<b>Title: Retrofit of an additional heat protection for the lower ignition cables for 915iS</b>		
<b>AG-SB-2024-2-B-EN</b>	<b>Effective Date:</b>	<b>Compliance Category:</b>  <del>A – MANDATORY</del> <del>B – RECOMMENDED</del> <del>C – OPTIONAL</del>
<b>Applicability</b>		
<b>Aircraft type &amp; model:</b>  Cavalon	<b>Affected Serial number(s):</b>  All fitted with Rotax 915iS engines up to serial V00564	
The maintenance manual to be referenced is this stated or subsequent issue.		As per AutoGyro website
<p>This form is the response from AutoGyro GmbH either against a problem found in the product in service requiring a containment or rectification action, or as service information for aircraft modification incorporation. For help, contact <a href="mailto:airworthiness@auto-gyro.com">airworthiness@auto-gyro.com</a>.</p>

Following market feedback, AutoGyro has improved the Rotax heat protection for the lower spark plug leads for Cavalon 915iS engines by the fitment of additional heat protection sleeves.

Old version with only Rotax heat protection:

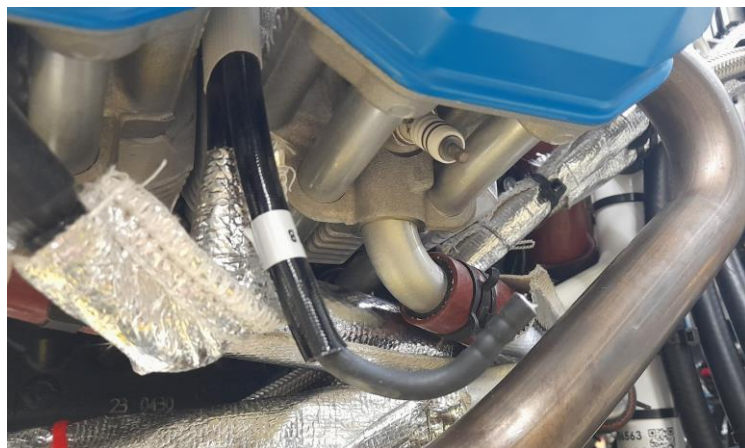
Rotax heat protection

Cable tie and spark plug connector removed:

- 1.) Remove the cowling according to chapter 52-00-00 4-1.
- 2.) Remove the lower spark plug connectors from the spark plugs, noting which plug lead number connects to which plug, and remove the cable ties
- 3.) Unscrew the lower spark connector plugs from the ignition cables
- 4.) Add the additional heat protection
- 5.) Screw the spark plug connectors securely back onto the cables
- 6.) Install new cable ties and refit the spark plug connectors to the plugs. Ensure the correct plug connectors are connected to the correct plugs!
- 7.) Perform a test run of the engine
- 8.) Re-install cowlings according to 52-00-00 4-1

New version with Rotax and AutoGyro heat protection:

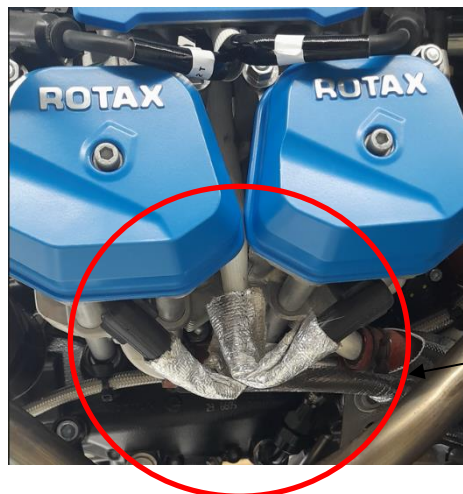
Spark plug connector screwed back on and new cable tie installed:

Additional AutoGyro heat protection

48711 – heat protection ignition cable motor kit
